Application No. A/NE-TKL/837

Section 16 Planning Application for Temporary Open Storage of Recycling Materials and Metalware with Ancillary Office for a Period of 3 Years at Lots 86 (Part), 87 and 89 in D.D. 83 and Adjoining Government Land, Kwan Tei North, Fanling, New Territories

Submission of Further Information 1

Responses to Departmental Comments

DWG NO. -

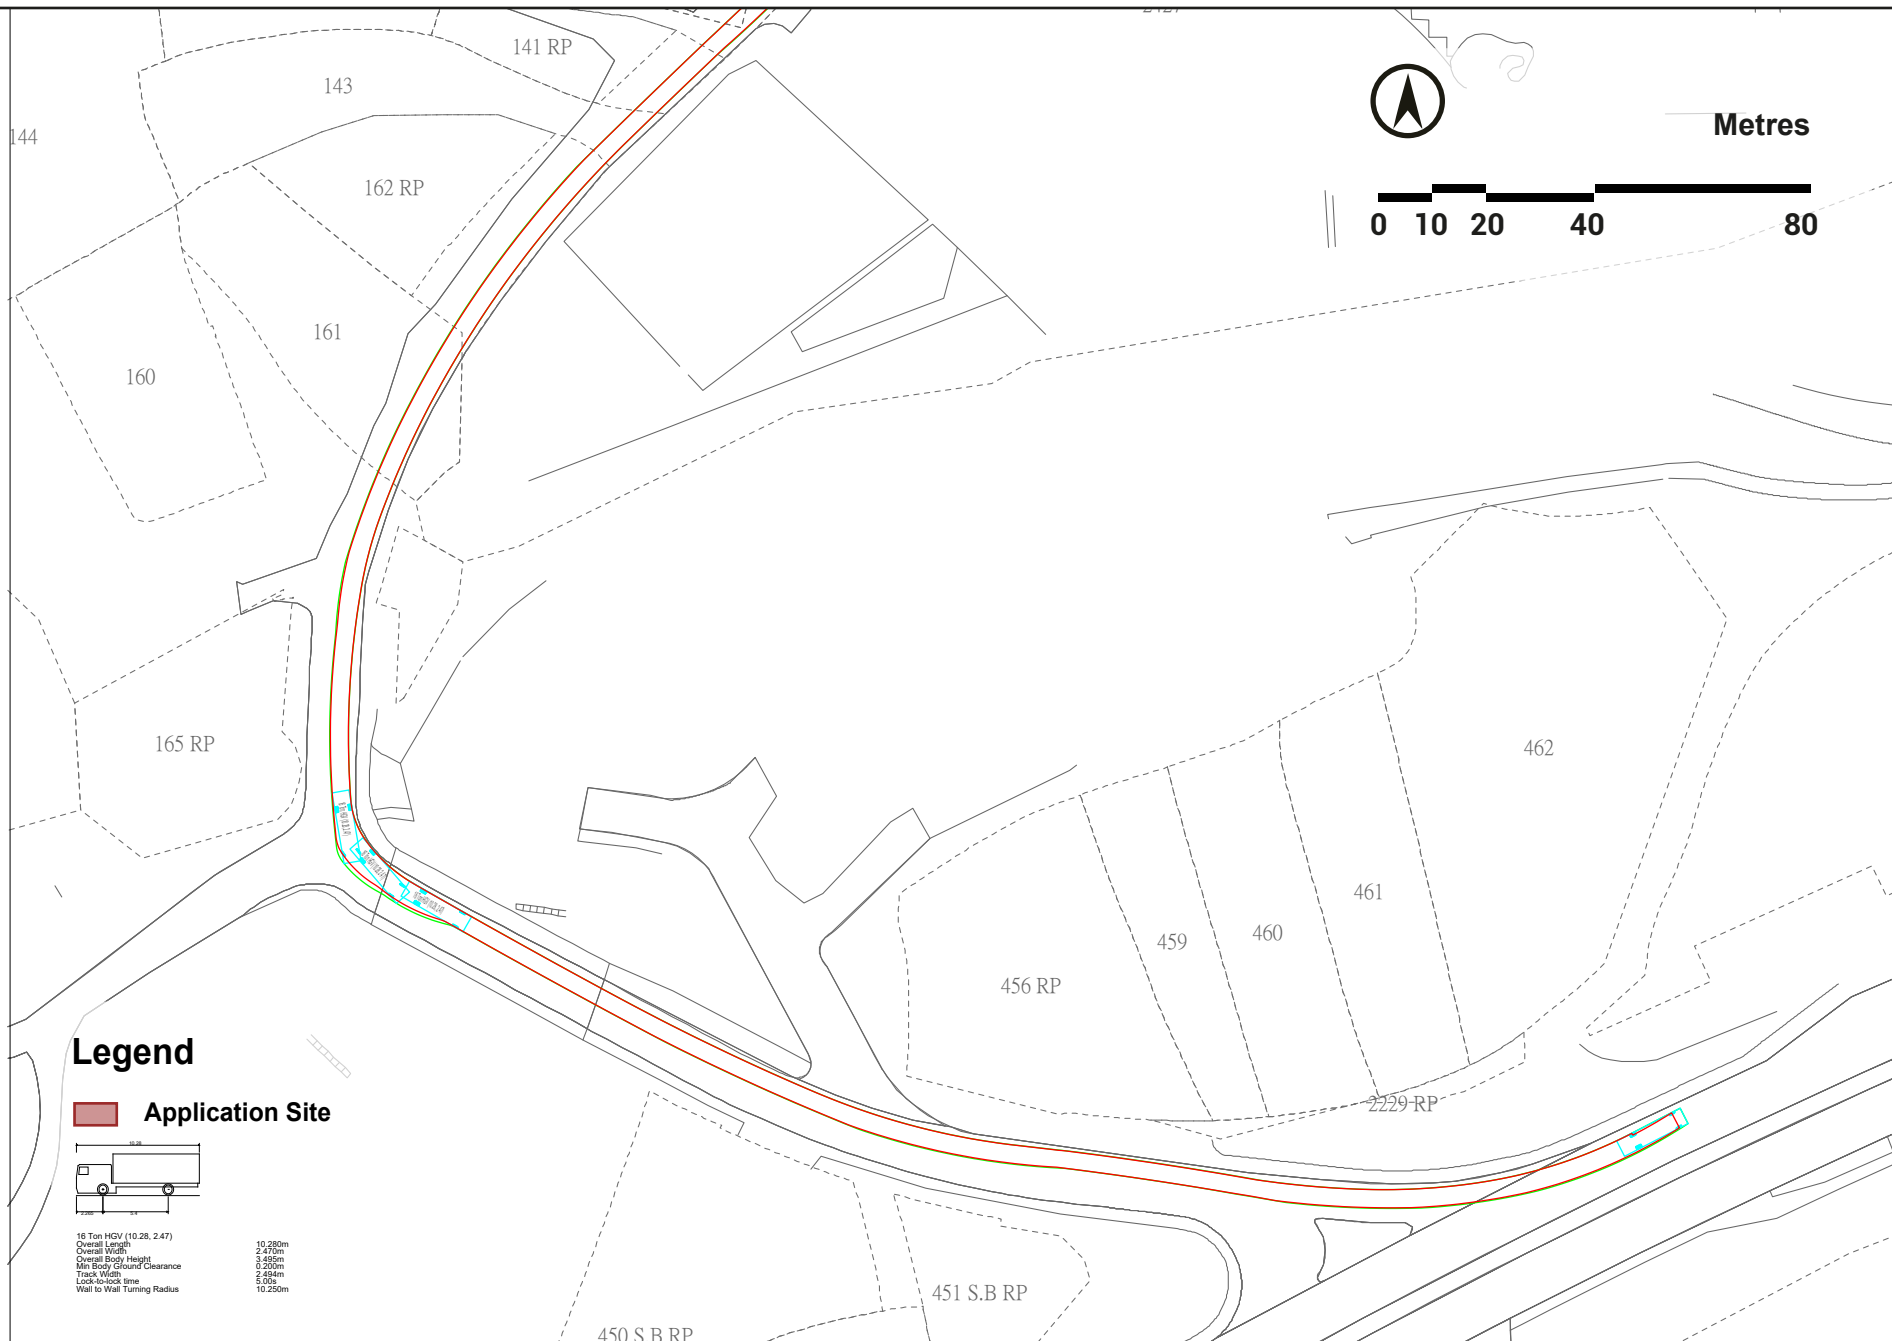
2.	Please supplement swept path analysis demonstrating satisfactory maneuvering of MGV-type vehicle to and from the development site;	According to the last approved application (No. A/NE-TKL/735), the Applicant submitted a swept path analysis for a 16-ton HGV, which indicates sufficient manoeuvring space for the MGV-type vehicle under the current application. Please refer to Annex 1 .

Revised Layout Plan

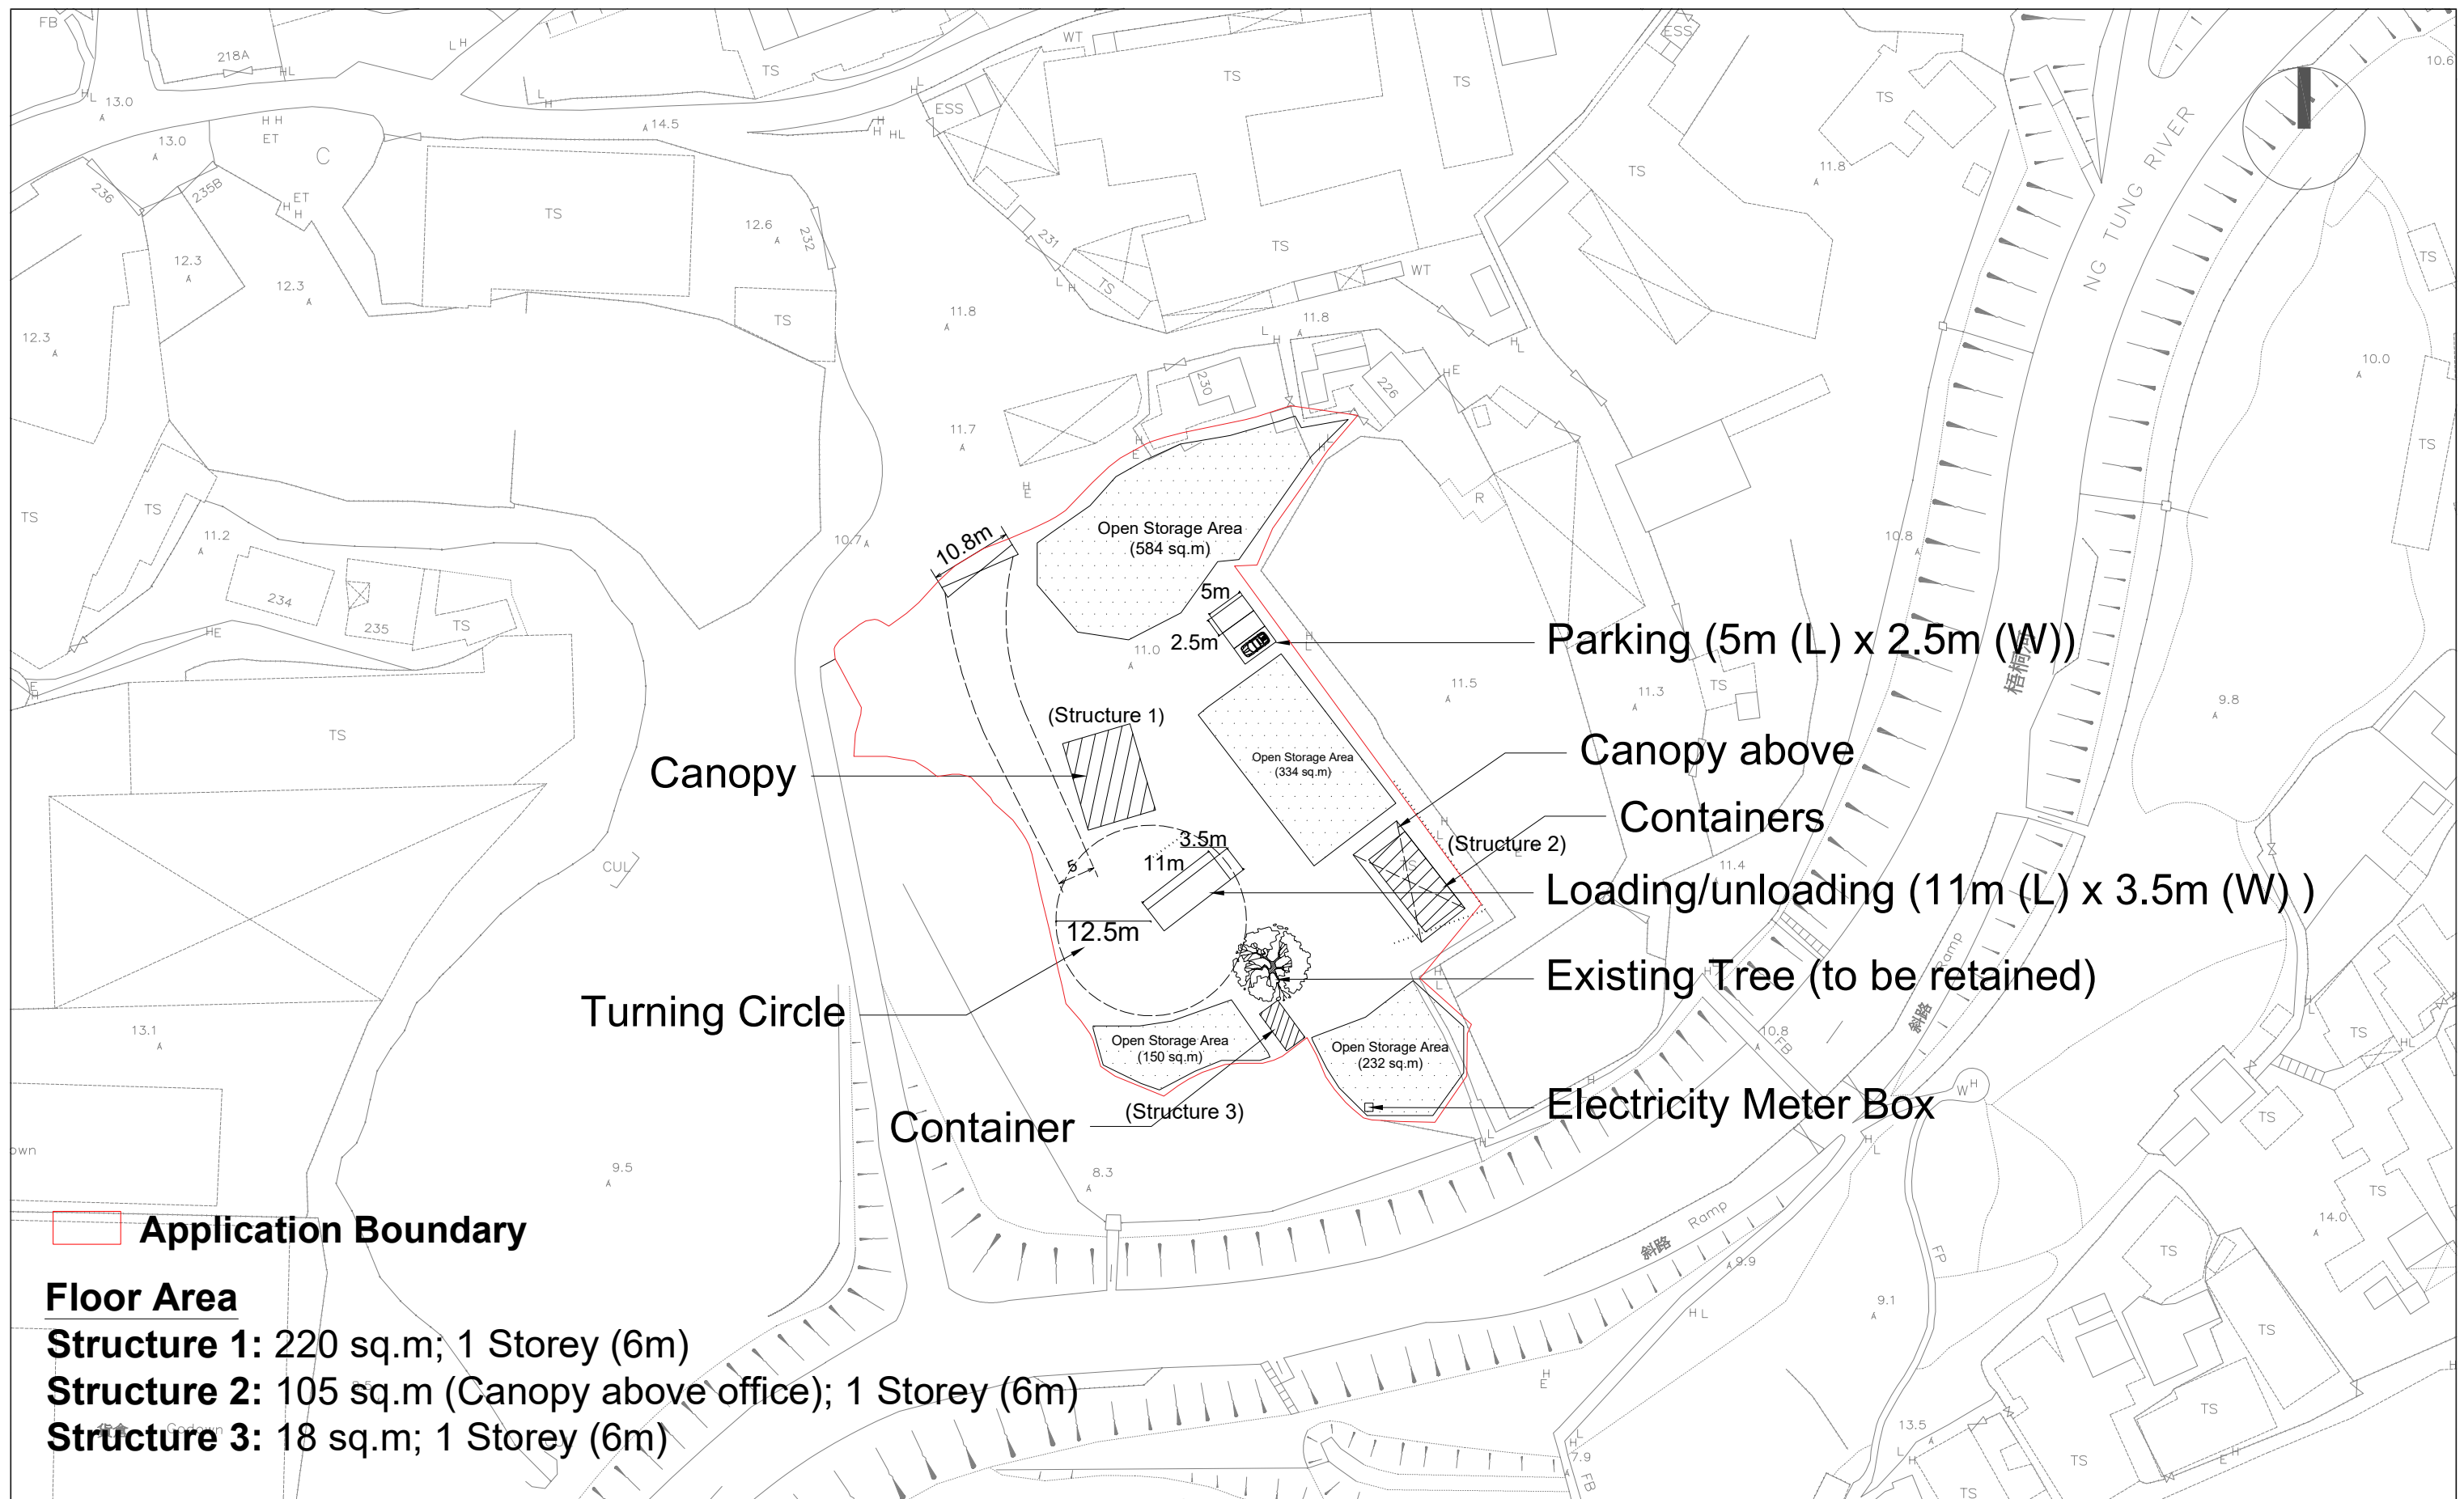
3. Comments from Planning Department received on 4.5.2026		
1.	Please clarify the area and location of the open storage use.	The area and location of the open storage use have been indicated on the revised layout plan at Annex 2 .

4.	From our recent site visit, it is found that the actual number of structures erected at the application site is not the same as the submitted layout plan. Please either (i) update the total number of structures erected at the application site and supplement with a revised layout plan; or (ii) undertake that the layout plan will be strictly adhered to upon receiving planning approval.	The Applicant ensures that the applied use will be carried out in accordance with the layout plan upon obtaining planning approval.
